## ADDENDUM NO. 2

Project: BL000A Site - Woodlawn Stormwater Collection System (Railroad)  
IU 20192159

BRCJ Project No.: 10570

Date: April 15, 2026

**Plan Sheet C102 – Maintenance of Traffic Plan**  
**Add General Note E, as follows:**

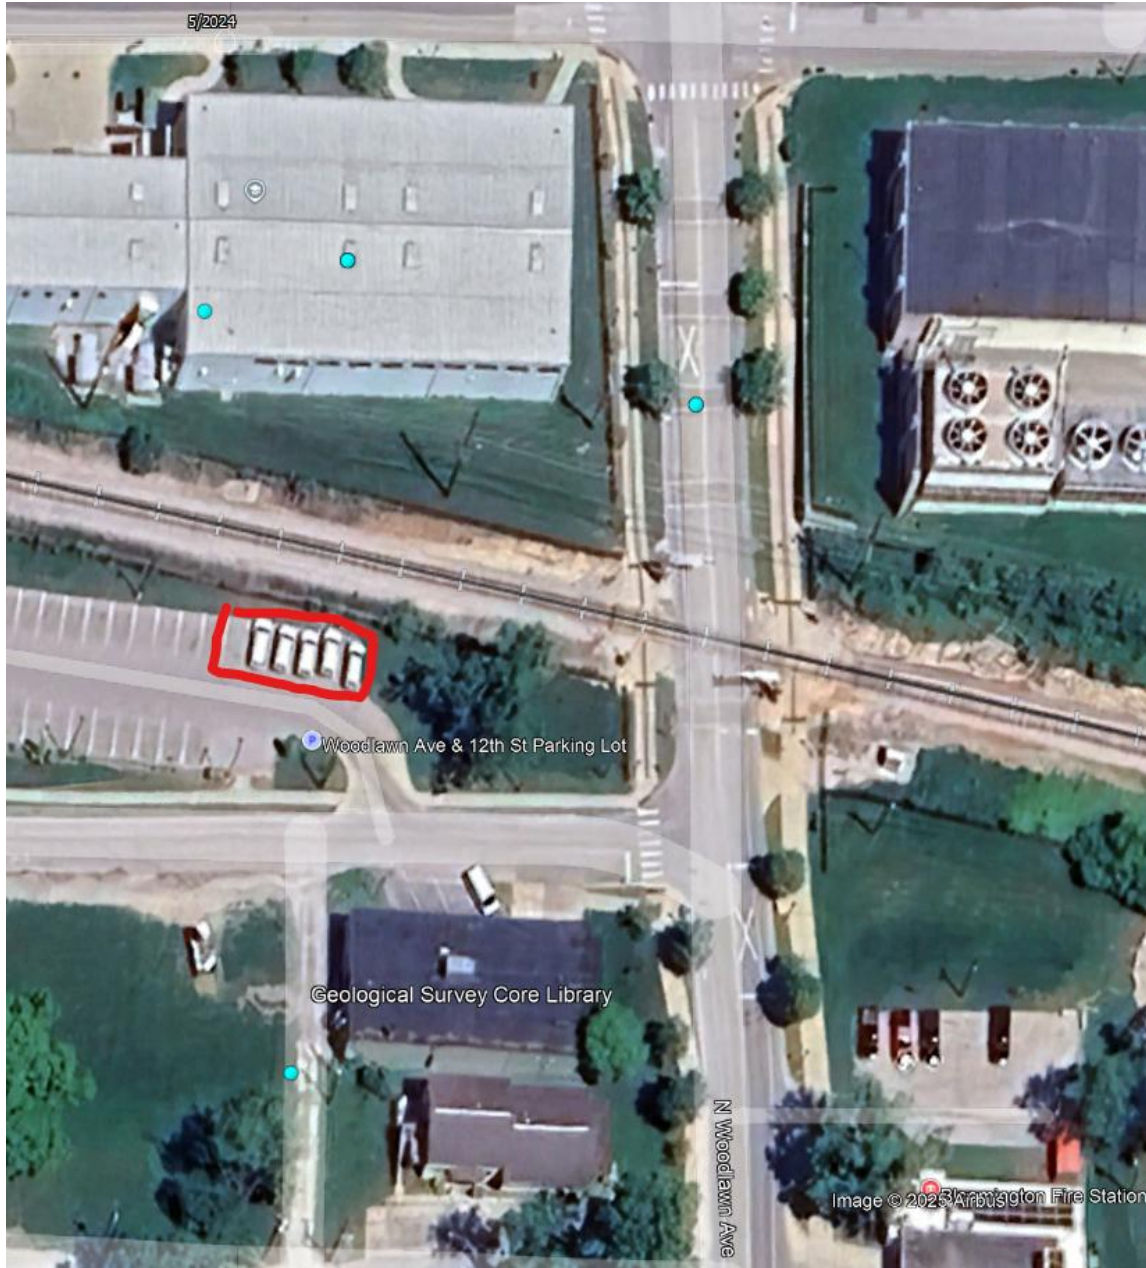
E. Signage indicating “Sidewalk Closed Cross Here” shall be mounted on a Type III barricade positioned to block the sidewalk on the west side of Woodlawn Ave, and direct pedestrians to the east sidewalk, which shall remain open for the duration of the project.

**1. Contractor Staging Area Exhibit**

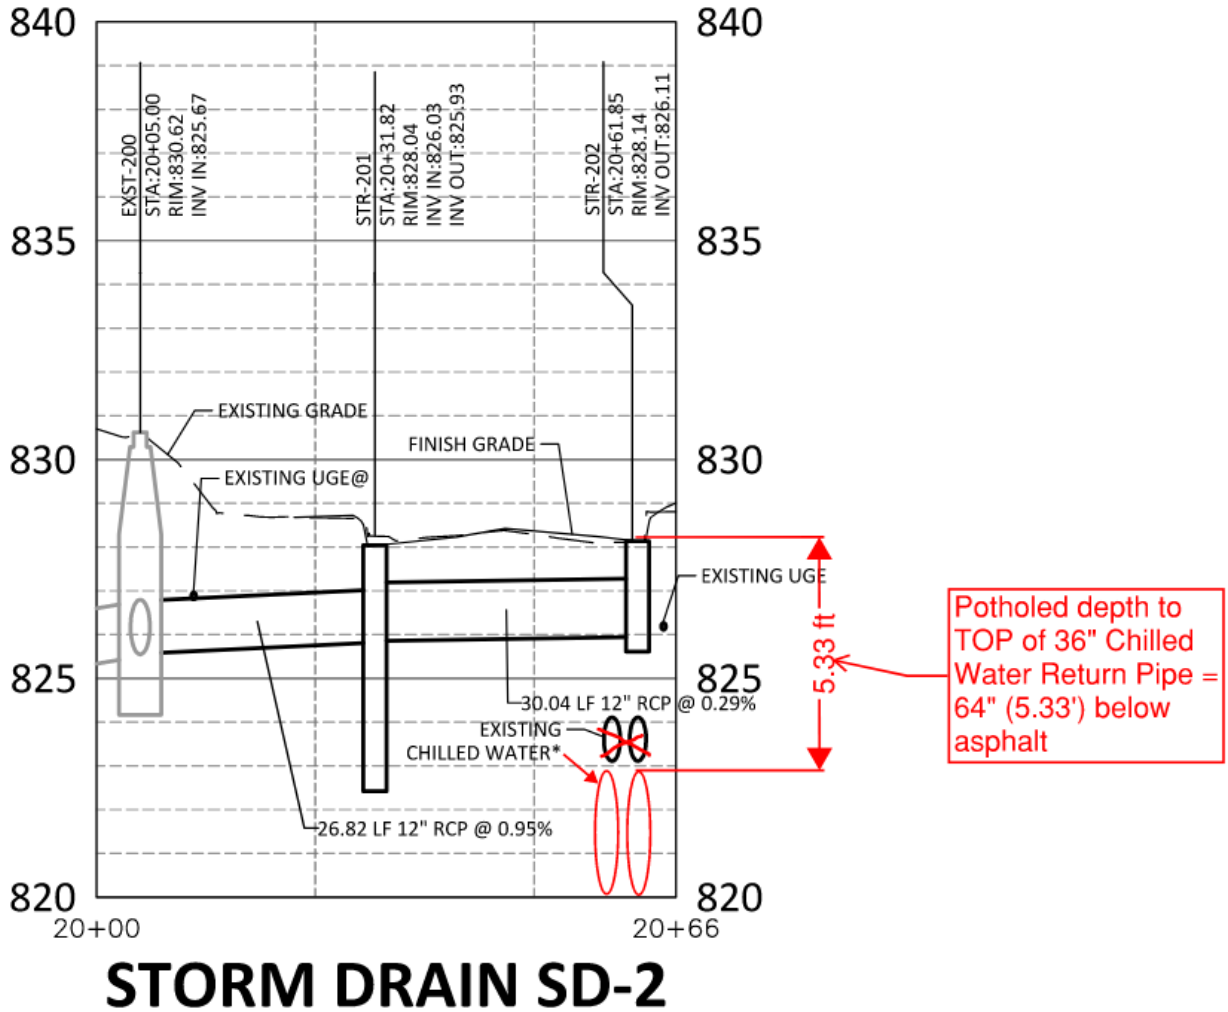
- Q2: Where will contractor staging or parking be located?  
A2: Six parking spaces will be reserved for contractor use in the parking lot to the west. The area must be surrounded with temporary construction fencing having red screen fabric per standard IU protocol. The area may only be used to store materials or construction equipment; vehicles are not allowed to be parked within areas reserved for laydown. If additional parking is needed for Contractor personnel, they may park in the Green Lot near Assembly Hall and shuttle to the construction site. Refer to staging area exhibit, attached to this Addendum, below.

Contractor may use six parking spaces indicated in red for staging and storage. The area must be surrounded with temporary construction fencing having red screen fabric per standard IU protocol.
